PLANNING APPROVAL,
PLANNED UNIT DEVELOPMENT &
SUBDIVISION STAFF REPORT

Date: January 21, 2010

<u>NAME</u>	UMS-Wright Corporation
<u>SUBDIVISION NAME</u>	UMS-Wright Corporation
<u>LOCATION</u>	65 North Mobile Street (Southwest corner of North Mobile Street and Old Shell Road, extending North and West to the CN Railroad right-of-way and the South terminus of Martin Street)
<u>CITY COUNCIL DISTRICT</u>	District 1
<u>PRESENT ZONING</u>	R-1, Single-Family Residential District
<u>AREA OF PROPERTY</u>	1 lot / 51.8 acres \pm
<u>CONTEMPLATED USE</u>	Planning Approval to amend a previously approved Planning Approval Master Plan to allow a new practice field for softball and soccer and new parking area at an existing private school in an R-1, Single-Family Residential District, Planned Unit Development Approval to amend a previously approved Planned Unit Development Master Plan to allow a new practice field for softball and soccer and new parking area, and Subdivision approval to create one legal lot of record.

SITE PLAN

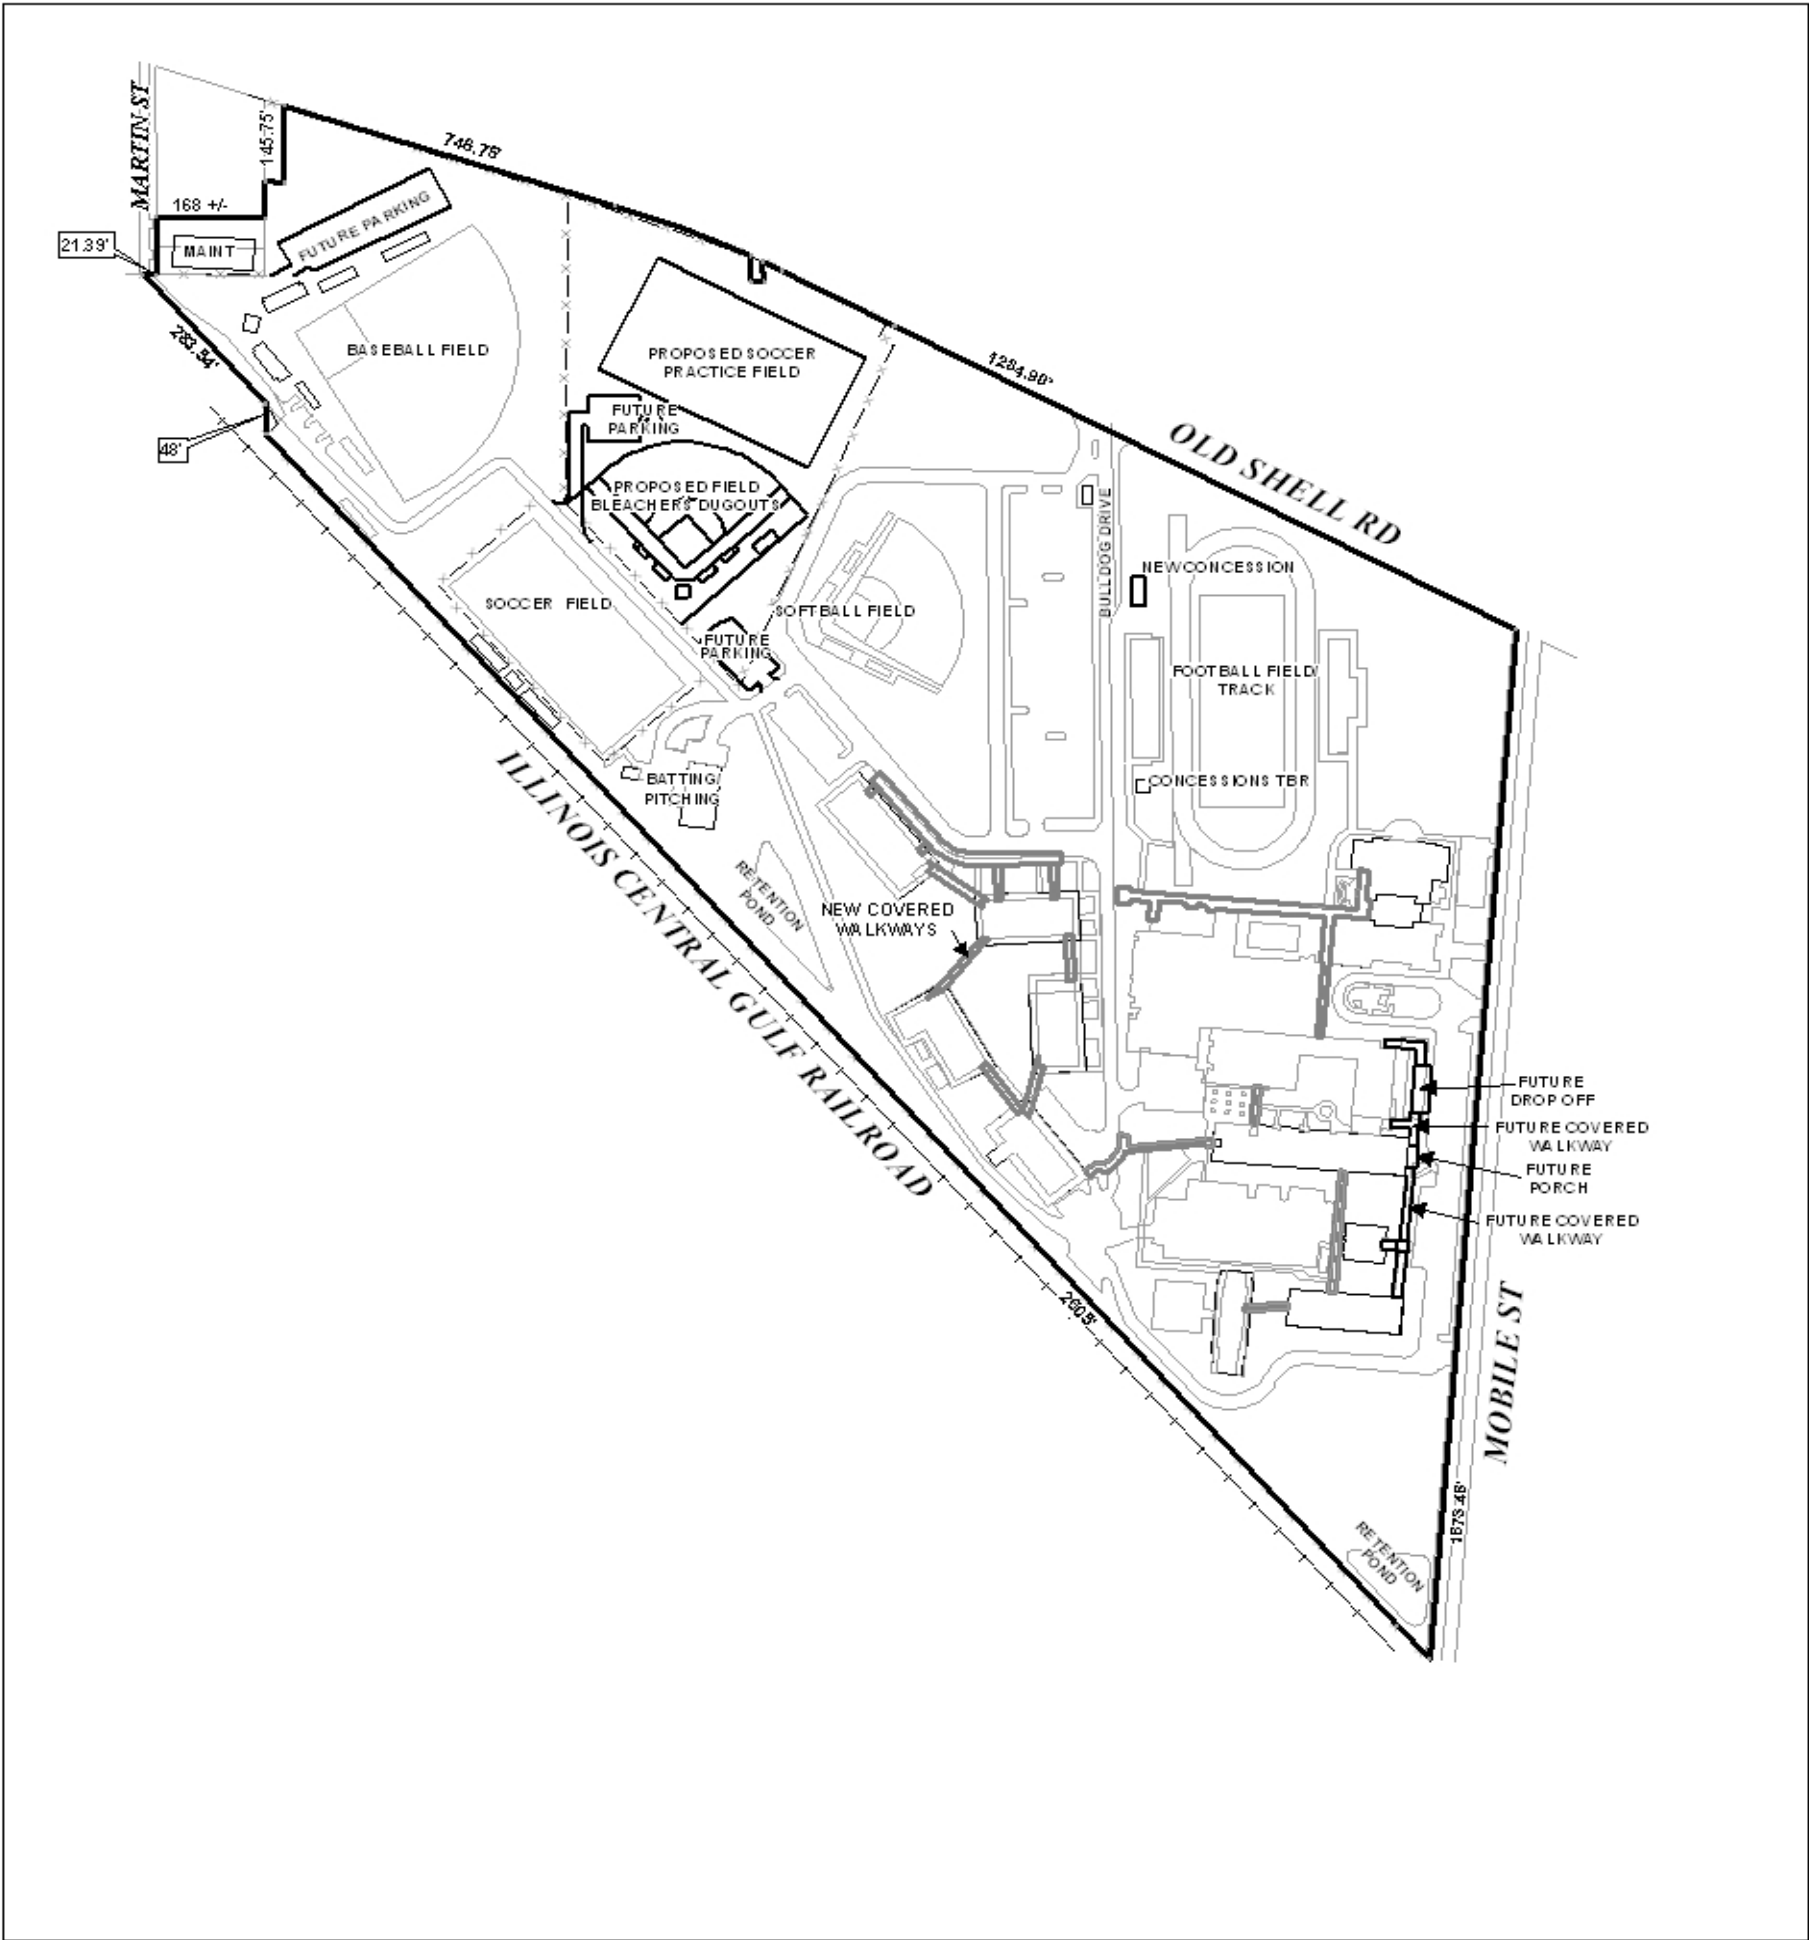
With regards to site circulation, the site plans illustrates a future parking lot, to which there appears to be no access. Furthermore, the future roadway that encompasses the proposed practice fields has no designated end point, thereby serving no purpose. These are certainly issues that need to be addressed.

It should be noted that the road which encompassed the proposed development with no ending point has been removed from the site plan: the road now terminates at a proposed parking lot.

It should also be noted that the site plan illustrates the existing concession stand being removed from the Southwest portion of the football field/track and replaced with a new larger concession stand at the Northwest portion of the football field/track.

The site plan also illustrates new lighting for the proposed softball fields, as well as a press box, concession stands and dug-outs. As stated in the initial review of the application, all lighting must comply with the requirements of the Zoning Ordinance: lighting should not shine onto adjacent residential property or into the street.

It should be pointed out that the applicant is proposing a covered walkway and drop off canopy on the Mobile Street side of the site with this application. No parking spaces will be lost, and site circulation should not be impacted.

No time frame has been provided regarding the development of the proposed “future” parking areas. The distance between existing paved parking and most of the athletic fields will result in continued parking on grass during events at existing and proposed fields on the West side of the site. Parking on grass is prohibited by the Zoning Ordinance.

- 1) Completion of the Subdivision process prior to application for building/Land Disturbance permits;
- 2) Depiction and provision of a 6-foot high wooden privacy fence around the perimeter of the site where it abuts existing residential development (Northwest portion), with the exception of within 25-feet of a street right-of-way, where the fence shall not exceed 3-feet in height;
- 3) Removal of all barbed wire fencing and construction of new ornamental fence (with permits) as part of the practice field development;
- 4) Placement of a note on both site plans stating that lighting of the site will comply with the requirements of the Zoning Ordinance;
- 5) Provision of trees and landscaping to bring the site into compliance with the requirements of the Zoning Ordinance; and
- 6) Full compliance with all other municipal codes and ordinances, and the obtaining of the appropriate permits.

- 1) Completion of the Subdivision process prior to application for building/Land Disturbance permits;
- 2) Depiction and provision of a 6-foot high wooden privacy fence around the perimeter of the site where it abuts existing residential development (Northwest portion), with the exception of within 25-feet of a street right-of-way, where the fence shall not exceed 3-feet in height;

- 3) Removal of all barbed wire fencing and construction of new ornamental fence (with permits) as part of the practice field development;
- 4) Placement of a note on both site plans stating that lighting of the site will comply with the requirements of the Zoning Ordinance;

- 5) Provision of trees and landscaping to bring the site into compliance with the requirements of the Zoning Ordinance; and
- 6) Full compliance with all other municipal codes and ordinances, and the obtaining of the appropriate permits.
